Totalflow product line

Technical bulletin 196

Notification regarding G4 32MB engine card modification and system resets

Date: **3/15/2013**

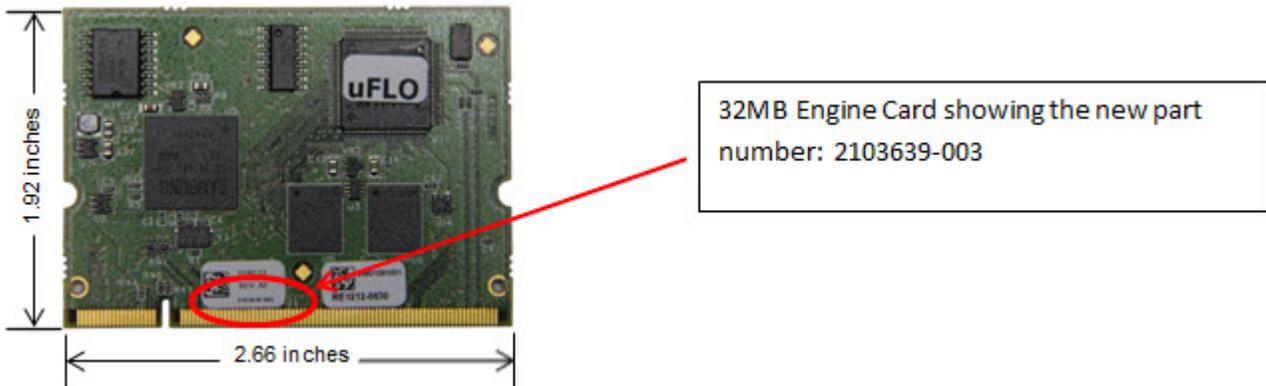
The hardware that is affected is the 32MB engine card used on G4 products prior to February 2013.

The following products are affected:

- XFC^{G4} with 32MB engine card part numbers of 2103639-001 and 2103639-002. The OS (Operating System software) part numbers would reflect 2104445-004 or older. US flash part numbers would reflect 2102861-047 or older, and Selectable Unit flash part numbers would reflect 2104339-016 or older.

- XRC^{G4} with 32MB engine card part numbers of 2103639-001 and 2103639-002. The OS (Operating System software) part numbers would reflect 2104446-004 or older. US flash part numbers would reflect 2103132-047 or older, and Selectable Unit flash part numbers would reflect 2104340-016 or older.

- μFLO^{G4} (microFLO^{G4}) with 32MB engine card part numbers of 2103639-001 and 2103639-002. The OS (Operating System software) part numbers would reflect 2104464-005 or older. US flash part numbers would reflect 2104497-011 or older, and Selectable Unit flash part numbers would reflect 2104498-011 or older.

- XFC^{G4}6200/6201EX with 32MB engine card part numbers of 2103639-001 and 2103639-002. The OS (Operating System software) part numbers would reflect 2104447-004 or older. US flash part numbers would reflect 2104159-025 or older, and Selectable Unit flash part numbers would reflect 2104158-025 or older.

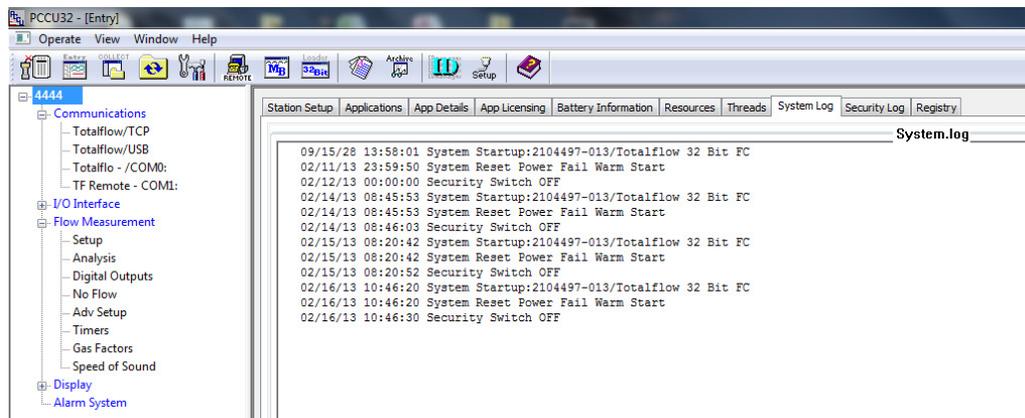
The voltage regulator was replaced on the 32MB engine card. The modified engine card has been thoroughly tested over temperature and does not exhibit the voltage drop at reduced operating temperatures that the previously used regulator exhibited. This voltage drop was the root cause of the 32MB engine card system resets that were randomly observed and has been resolved with the modified engine card. The new engine card may be identified by part number 2103639-003 or greater on the card itself. Each card will also have a sticker indicating the hardware platform that it is designed for. The new engine card shown below reflects that it is the new part and is for a μ FLO^{G4}.

The software (Operating System and flash) has also been updated and is installed on the appropriate engine cards. Users will be able to identify any units that may have this upgrade installed by referring to the attached sticker and verifying the part number to be 2103639-003 or greater. **Please note that this only affects engine cards with the base part number 2103639. If you have an engine card that is a different base part number, this Technical Bulletin does not apply.**

If the product being upgraded is either a μ FLO^{G4} or EX^{G4}, it is recommended that the RTD input upgrade cable be installed at this time as well. (See Totalflow Technical Bulletin 197 for additional details pertaining to this cable upgrade.) Totalflow recommends that 32MB engine cards with the affected part numbers shown above be replaced with 2103639-003 or newer.
